NOTICE OF DECISION – Bureau of Mining Regulation and Reclamation

Ioneer USA Corporation Rhyolite Ridge Project WPC Permit NEV2020107

The Administrator of the Nevada Division of Environmental Protection (the Division) has decided to issue renewed Water Pollution Control Permit **NEV2020107** to **Ioneer USA Corporation**. This Permit authorizes the construction, operation, and closure of approved mining facilities in Esmeralda County, Nevada. The Division has been provided with sufficient information, in accordance with Nevada Administrative Code (NAC) 445A.350 through 445A.447, to assure that the waters of the State will not be degraded by this operation, and that public safety and health will be protected.

PROJECT: Rhyolite Ridge Groundwater Model Impacts Report
DRAWN: DE
FIGURE: 1.3a
CHECKED: AL

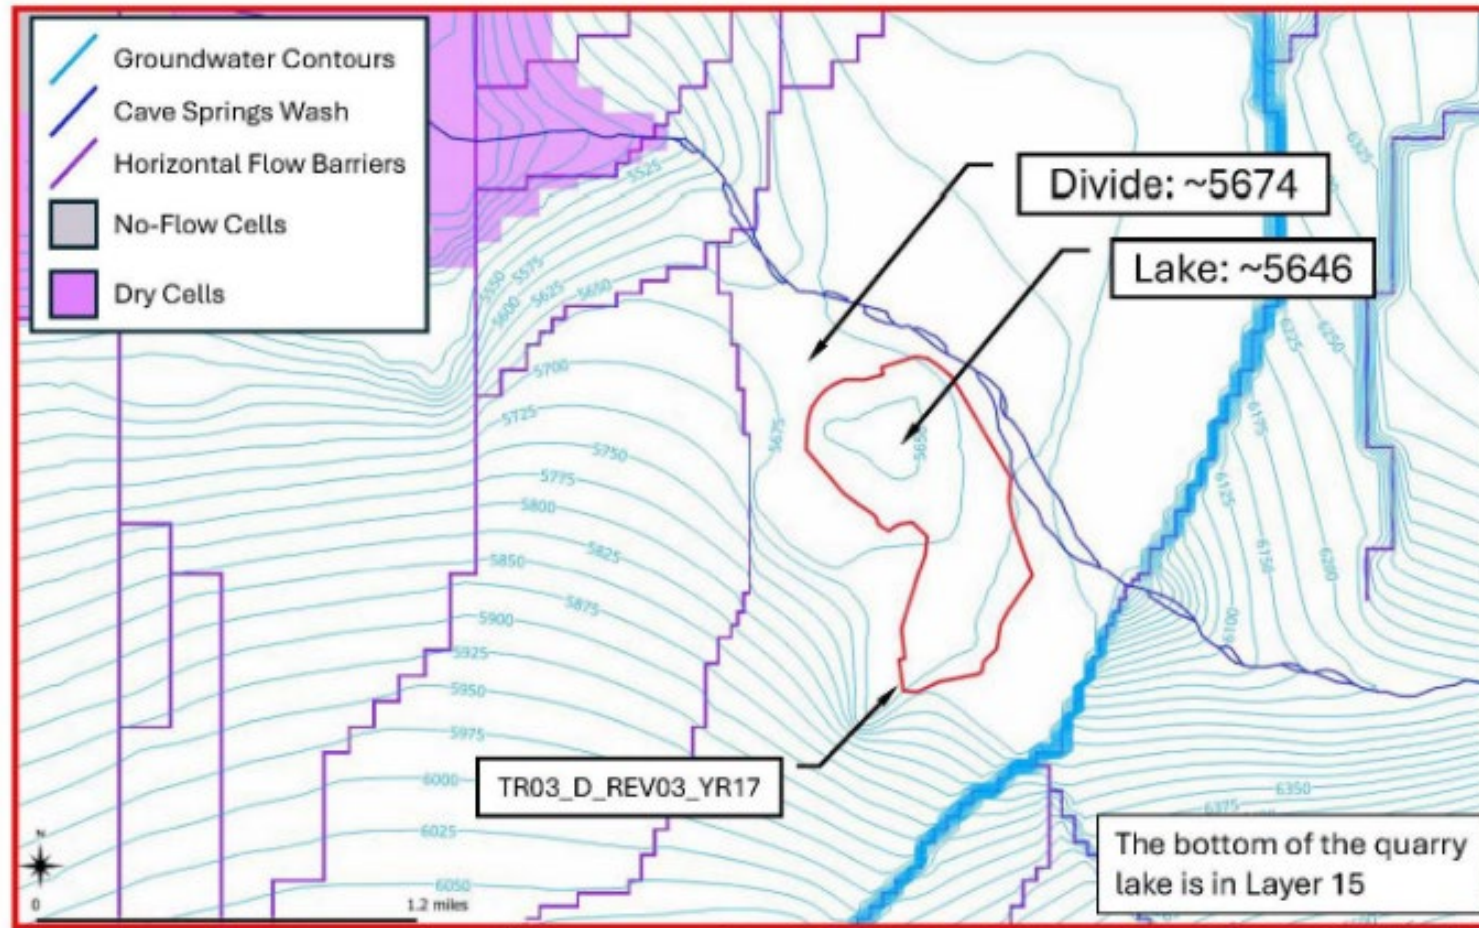
If the pit lake level exceeds the final groundwater level in surrounding aquifers, there could be flow from the pit lake into the aquifers. Piteau (2023) Figure 4.11 shows the piezometric surface 200 years post closure. There is a closed piezometric contour at 5,650 AMSL in the pit; presumably this contour represents groundwater level intersecting with the pit. This groundwater level is only 4 feet higher than the pit lake. The low ET scenario would result in a pit lake higher than the groundwater level which would allow water to discharge into the aquifers.

Also Piteau did not consider vertical gradients in the groundwater. Piteau (2023) Figure 4.11 shows piezometric surface in model layer 14. However, more layers intersect the pit lake. Some layers could have a lower piezometric surface and pit lake water could discharge into those layers. The modeler should present the piezometric surface for all layers connected to the lake and should also present the flux across the pit lake/geologic layer boundary. Inflow from the lake into just one layer is still a flow-through lake.

The groundwater divide is at an elevation of approximately 5,674 feet (ft) above mean sea level (amsl) after 200 years of quarry lake recovery. This is higher than the ultimate quarry lake elevation of 5,646 ft amsl providing 28 feet of elevation change, not four-feet of elevation change as stated by GBRW. As stated in Appendix C of the WPCP Application, the final model results show that the quarry lake exists only in layers 14 and 15. Figures 1.3a and 1.3b (below) show groundwater contours for layers 14 and 15 at 200 years post-mining. In both cases, the maps show that the piezometric levels in the aquifer adjacent to the pit lake are always higher than the ultimate quarry level of 5,646 ft amsl. These maps show that the quarry lake is a terminal lake. Figures 1.3c and 1.3d (below) show velocity vectors for layers 14 and 15. In all cases, the vectors along the perimeter of the ultimate quarry outline (labeled with TR03_D_REV03_YR17) show that groundwater gradients are directed inward, towards the quarry lake. Based on a holistic analysis of the model results, the ultimate quarry lake is a terminal lake in all layers.
